MANDATORY SERVICE LETTER

SL-200C/400C-0002

TO: ALL OWNERS / OPERATORS OF AFFECTED PROPELLERS
SUBJECT: MANDATORY BLADE FERRULE ROOT MODIFICATION
DATE: FEBRUARY 4, 2003

MODELS AFFECTED: All Whirl Wind 200C Series and 400C Series aerobatic propellers manufactured prior to the date of this letter.

200C / 400C SERIES PROPELLER SL-200C-400C-0002 FASTENER INSTRUCTIONS

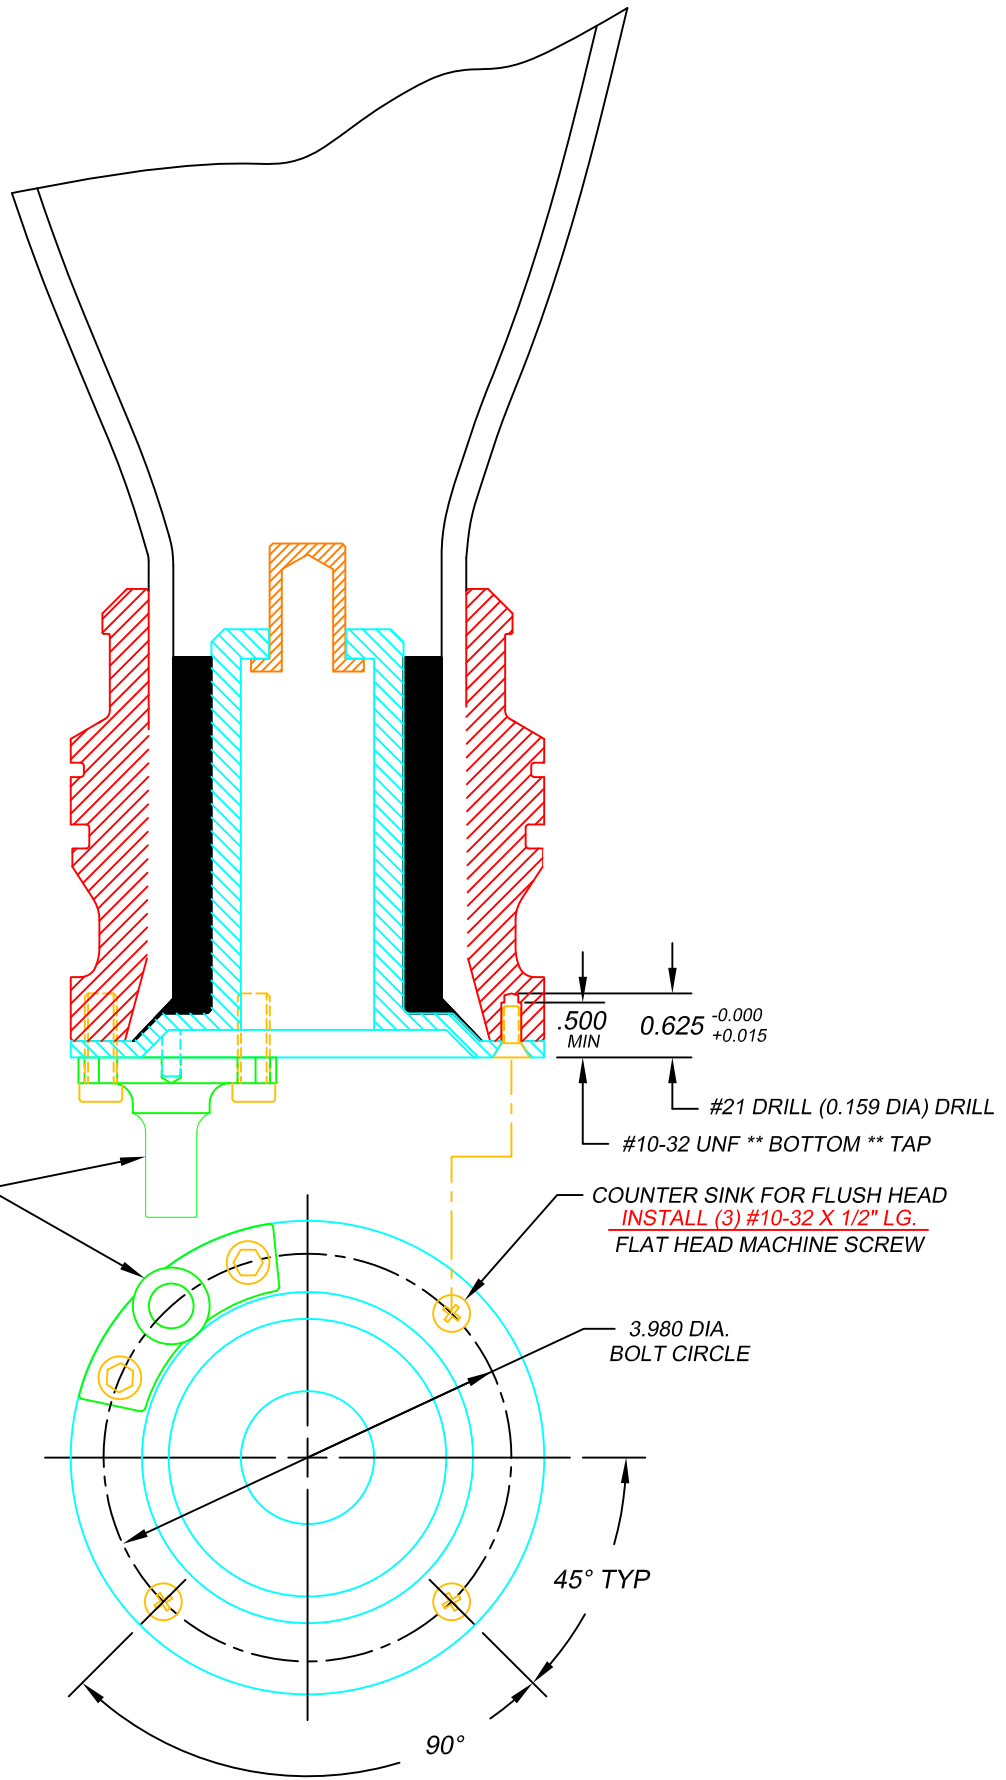
REASON: Blade root inner ferrule may slip resulting in loss of pitch control in affected propeller models.

1. A blade ferrule root modification must be performed for all affected propeller models. This modification will require the affected propeller models to be disassembled for the removal of the blades. The blade modification requires three #10 fasteners to be installed at the ferrule root of each blade. After the blade modification is complete, the propeller can then be reassembled and returned to regular service.
2. This modification can be performed by the Whirl Wind Propellers factory. Alternatively, a modification kit will be provided to a qualified propeller service center to perform this modification per Whirl Wind drawing upon approval by Whirl Wind.

.500
 MIN
 0.625 ^{-0.000}/_{+0.015}
 #21 DRILL (0.159 DIA) DRILL
 #10-32 UNF ** BOTTOM ** TAP
 COUNTER SINK FOR FLUSH HEAD
INSTALL (3) #10-32 X 1/2" LG.
 FLAT HEAD MACHINE SCREW
